# Access Compliance Report

## Public Rights-of-Way

Intersection ID: N/A	Main Street: GROVER_RD	Cross Street: N/A	Location: NE
ADA ID: B1CE65932FCB	Ramp Type: Perp	Initial Pass/Fail: Fail	Overall Compliance: No
Severity Score: 26.25			
Codes/Mitigation Info/Possible Solution		Field Measurements/Component Compliance

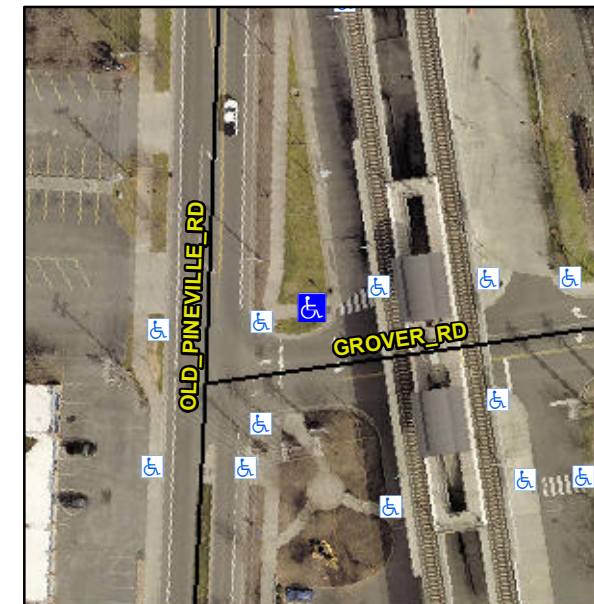
Compliance	Description	Data	Compliance	Description	Data
N/A	Ramp Length (in)	81.0	No	Ramp Slope (%)	13.7
Yes	Ramp Width (in)	48.0	Yes	Ramp XSlope (%)	2.5
N/A	Flare Type LT	N/A	N/A	Flare Type RT	N/A
N/A	Flare Slope LT (%)	N/A	N/A	Flare Slope RT (%)	N/A
N/A	Flare Traversable LT?	N/A	N/A	Flare Traversable RT?	N/A
N/A	Landing Length (in)	N/A	N/A	DWS Provided?	N/A
N/A	Landing Width (in)	N/A	N/A	DWS Contrast?	N/A
N/A	Landing Slope (%)	N/A	N/A	DWS Length (in)	N/A
N/A	Landing X Slope (%)	N/A	N/A	DWS Full Width?	N/A
N/A	Landing Curb? (Y/N)	N/A	N/A	DWS Offset (in)	N/A
N/A	Shared Landing?	N/A			
N/A	Gutter Ponding?	N/A	N/A	Gutter Slope (%)	N/A
N/A	Gutter Lip Ht (in)	N/A	N/A	Gutter X Slope (%)	N/A
N/A	Painted X Walk1?	Yes	N/A	Painted X Walk2?	N/A
	X Walk 1 Direction	To E		X Walk 2 Direction	N/A
N/A	X Walk 1 Width (in)	120.0	N/A	X Walk 2 Width (in)	N/A
	X Walk 1 Slope (%)	0.1		X Walk 2 Slope (%)	N/A
	X Walk 1 X Slope (%)	3.0		X Walk 2 X Slope (%)	N/A

**Remove & Replace Entire Ramp.**

**R304.2.2**
